DEVELOPMENT REVIEW BOARD
SUPPLEMENTAL SUBMITTAL

PROJECT NO. PR-2021-006238

Application No. SI-2021-01916

Re: Allaso Louisiana Site Plan – DRB Comment Responses (PR-2021-006238)

A1 SITE PLAN
1" = 30'-0"
0 30' 60'

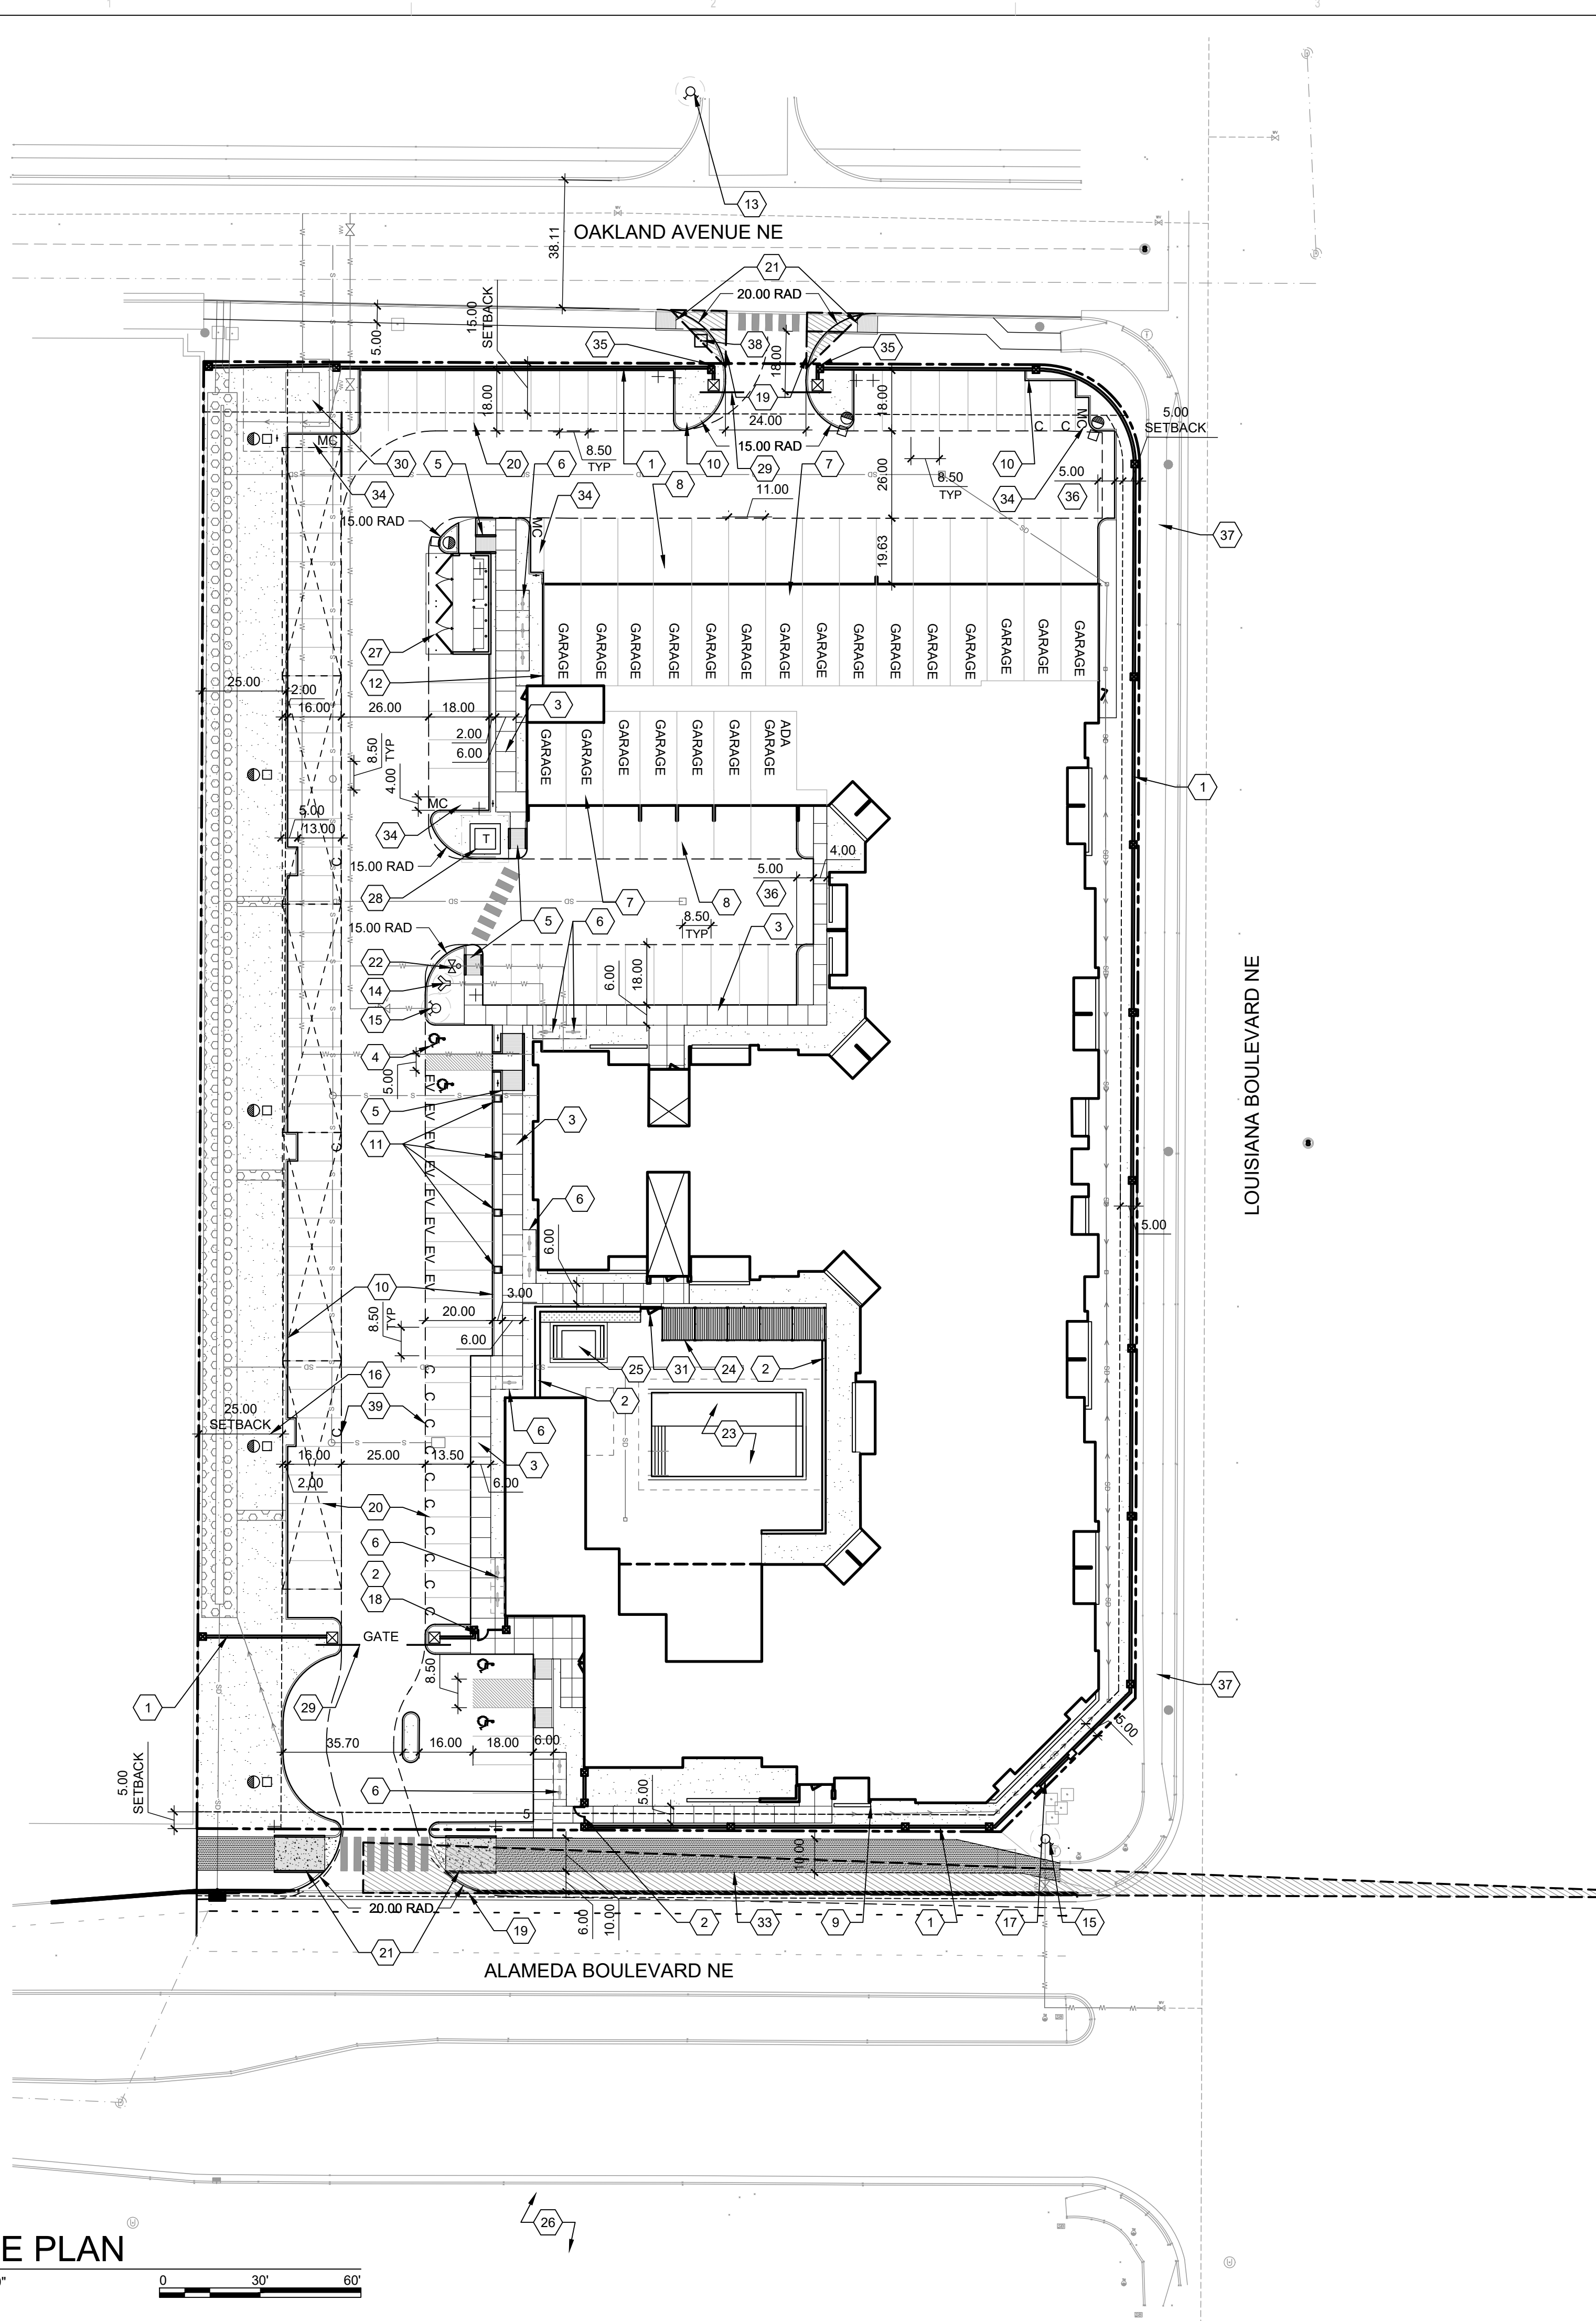
1. For Alameda Boulevard, due to speed limit, the clear sight triangle should represent intersection sight distance. Reflect on landscape plan.
2. For the clear sight triangles shown on Oakland, project triangle all of the way to the curb line.

6. Label all curb radii in accordance with DPM requirements.
7. Dimension all parking spaces, and make sure dimensions are called out on all segments, including the width.

10. Label a 5-foot parking lot keyway at the end of the parking lot for both locations where applicable.
11. The parking lot in the middle of the site plan should show a crosswalk to complete the ADA pathway. The curb ramp on the far north side does not lead to any continuous pathway to the north and appears to not be needed since the ADA connection to the right-of-way is to the south.

13. Call out all public sidewalk widths and landscape buffer widths on site plan. All new public roadway infrastructure shall be placed onto an infrastructure list.

- a. ***The clear sight triangles for both entrances have been updated on the Site Plan and Landscape Plan, as requested.***
3. Typically, the City of Albuquerque would request a turn-around or a decel lane for Oakland in addition to the one shown on Alameda Boulevard if using as ingress. There is also no space for any type of a queue before the Oakland gate. If Oakland is wide enough for two-way traffic in addition to a queue, present dimensioning on the site plan.

- a. ***Additional dimensioning and labels have been added for these items.***
8. If a parking space is compact, mark "Compact" in the back. If allowing for overhang as part of a standard parking space, label the overhang on the drawing. The maximum number of compact parking spaces in the IDO shall apply.

- a. ***Keyways are dimensioned and a crosswalk has been added to complete the ADA pathway across the middle parking area.***
12. Where are motorcycle spaces shown? Also, provide motorcycle sign parking detail along with "MC" at the back of the parking space.

- a. ***Sidewalk widths are dimensioned and have been placed on the infrastructure list.***

LS-01

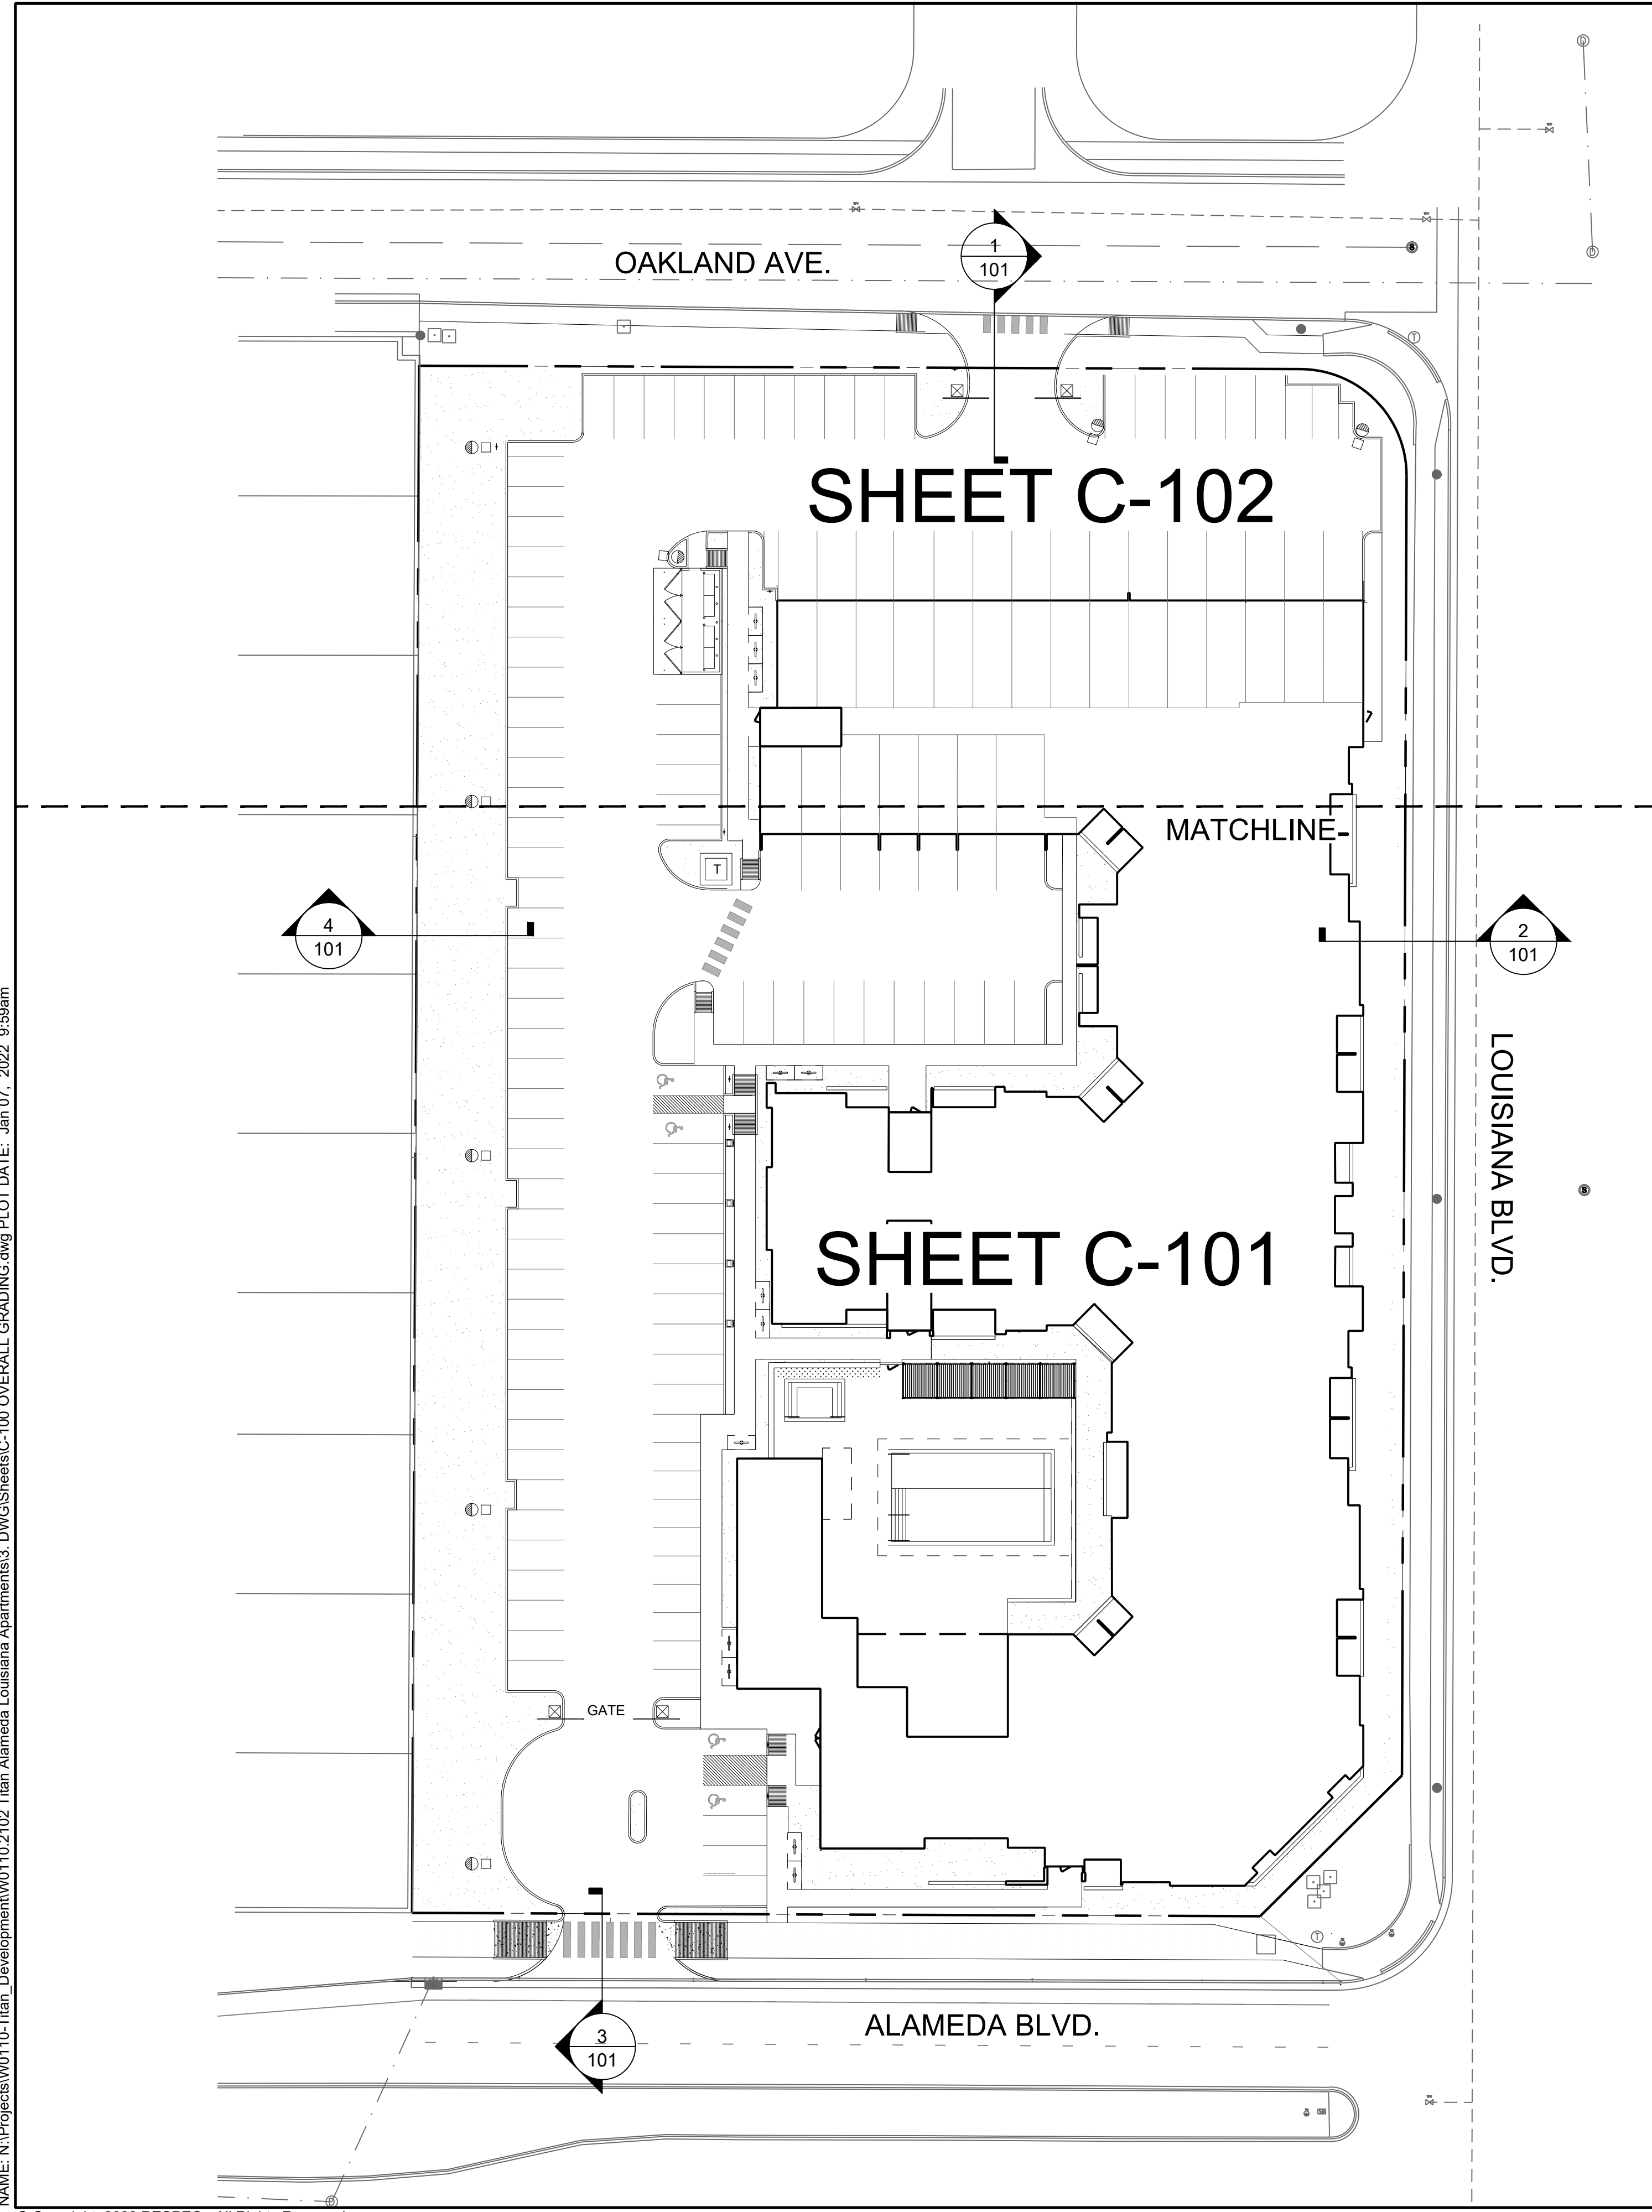
4. Utility Plan:
 - a. Please explain the proposed sand trap.
 - b. There shall be no trees, parallel fences/sidewalks/curbs, or structures within the public water and public sewer easement. Please revise landscape plan in the area of the water meter vault.

- a. **Understood.**
 3. 4-3(B)(7)(c) of the IDO pertaining to landscaping requirements including for the use-specific standards of 4-3(B)(7) for multi-family dwellings requires at least 50 percent of the trees be deciduous canopy-style shade trees or coniferous trees capable of attaining a mature canopy diameter of at least 25 feet. Confirmation needs to be provided if the shade trees on the Landscape Plan are capable of attaining a mature canopy diameter of at least 25 feet.

14. Alameda Blvd NE is a Regional Principal Arterial and Louisiana Blvd NE is a Major Collector, requiring street trees. The Parks and Recreation Department (PRD) is a partner with the Nature Conservancy who developed a Climate Ready Tree List for Albuquerque. PRD encourages developers to use this list for street trees (see insert below). Ash is not considered Climate Ready.
Lists linked here:
Trees must be recommended on the Official Albuquerque Plant Palette: [Official Albuquerque Plant Palette and Sizing List-2018-07-03.xlsx \(cabq.gov\)](#)
Please reference the CLIMATE-READY TREES FOR ALBUQUERQUE: [NMFO Climate-Ready Trees Lists \(nature.org\)](#)

- a. ***The landscape plan has been updated to remove landscaping from around the meter vault location.***
5. Infrastructure List:
 - a. No public water or sewer main extensions are required for this project.

- a. **This calculation has been added to the updated landscape plan. 34 are required to be deciduous of this size, and 35 are provided.**
 4. Please note that the 2020 IDO Update gave greater allowances for cool and warm seasons grasses for multi-family projects. Please see IDO Section 4-3(B)7 to see if there are allowances that would benefit your landscape plan.

- a. The landscape plan has been updated to replace the Ash trees with different species.**
